Comments by Paul Gunter

Peach Bottom EIS on License Extension, Delta, Pennsylvania, July 31, 2002

The Environmental Impact Statement Lacks an Adequate Evaluation of the Peach Bottom Primary Containment System

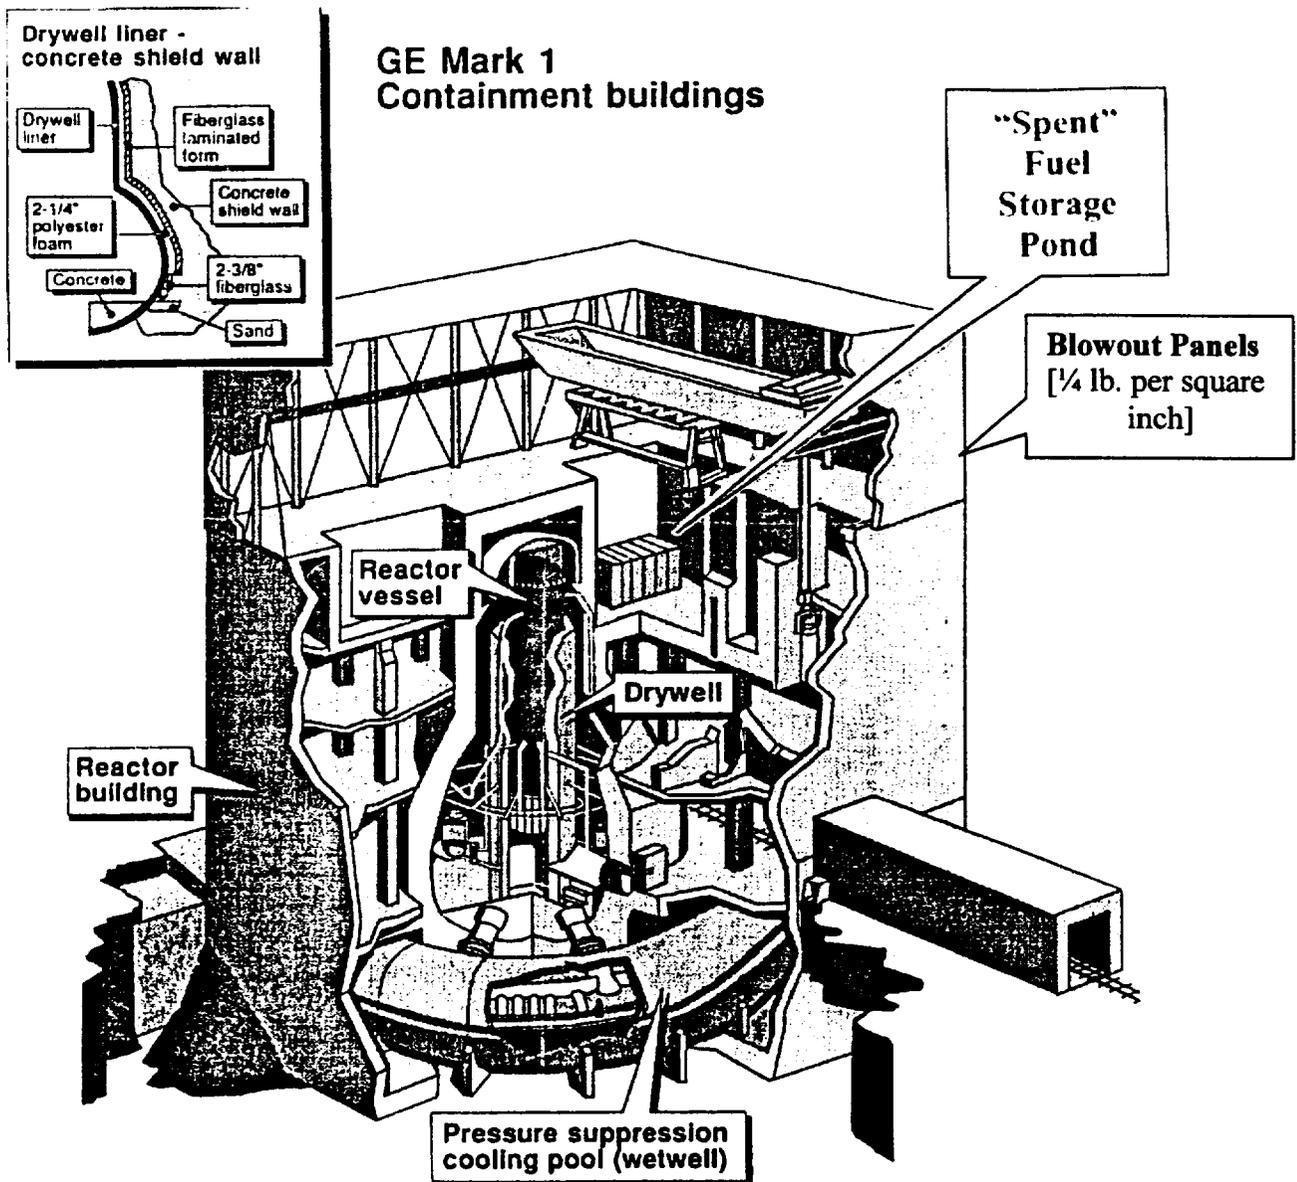
In 1972, the U.S. Atomic Energy Commission's (AEC) top safety advisory, Stephen Hanauer, in a confidential memo on the General Electric Mark I Containment (Pressure Suppression System) as used at Peach Bottom, concluded that the safety hazards inherent in the GE containment design were "preponderant," in excessive prevalence and recommended that the AEC not permit any more designs to be built.

The GE Mark I Pressure Suppression Containment System is primarily comprised of a "Drywell" where in the event of an accident highly radioactive steam issuing from the reactor's Emergency Core Cooling System would be routed through large diameter pipes underwater into the pressure suppression cooling pond or the "Wet-well." First thought to be of sufficient volume to quench the steam from sustained accident mitigation, subsequent safety analysis found the wet-well too small and would more likely rupture with an ensuing core melt accident. The reactor building is even less robust as a "secondary containment." The upper section of the Mark I reactor building is not a high pressure-rated structure as evidenced by "blow-out" panels designed to pop-out at one-quarter pound per square inch (psi). Just behind these blow-out panels is the reactor refueling deck including the open surface of the 40-foot deep nuclear waste storage pond containing the reactor's high-level nuclear waste.
